Migrating from the MC9S08GT16 to the MC9S08GT16A

by: Scott Pape
Systems and Applications Engineering
Microcontroller Division

This document explains the differences to be aware of when migrating from the MC9S08GT16 MCU to the MC9S08GT16A MCU. For the remainder of this document, GT16 will refer to the original non-“A” device and GT16A will refer to the newer “A” suffix device.

Figure 1. FLASH Program and Erase Flowchart

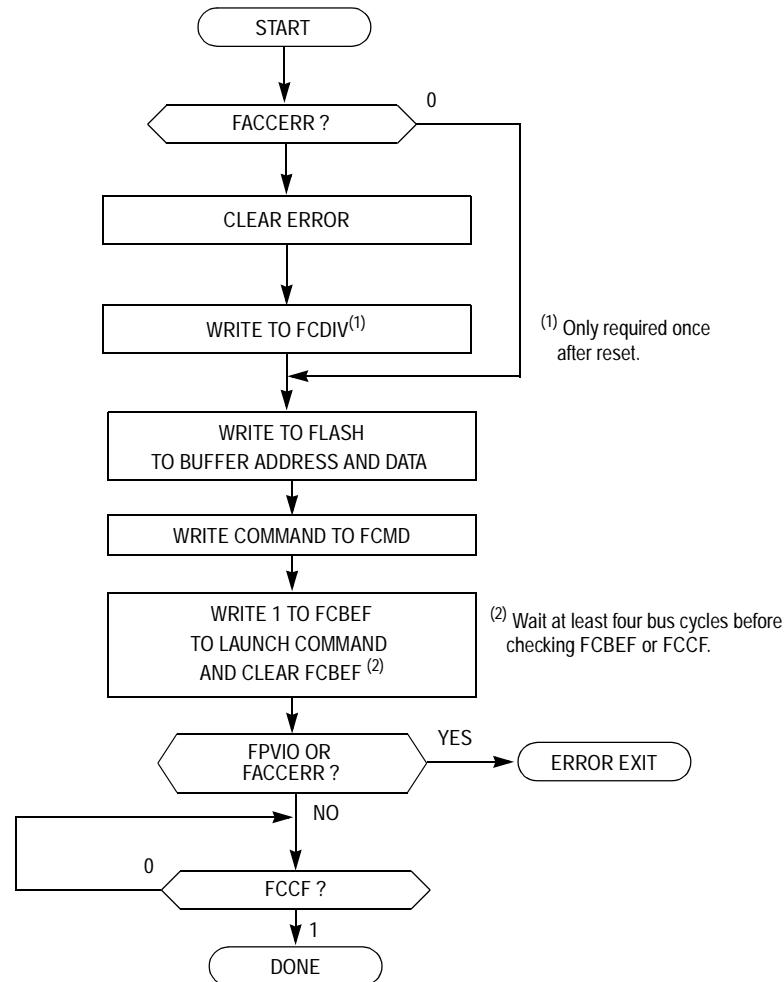
Refer to [Figure 1](#), the FLASH program and erase flowchart. On the GT16, the steps starting with “write to FLASH to buffer address and data” and ending with “FCCF?” must all be executed from RAM.

On the GT16A, execution from RAM is not required until the step, “write 1 to FCBEF to launch command and clear FCBEF.” Execution from RAM still concludes with “FCCF?”.
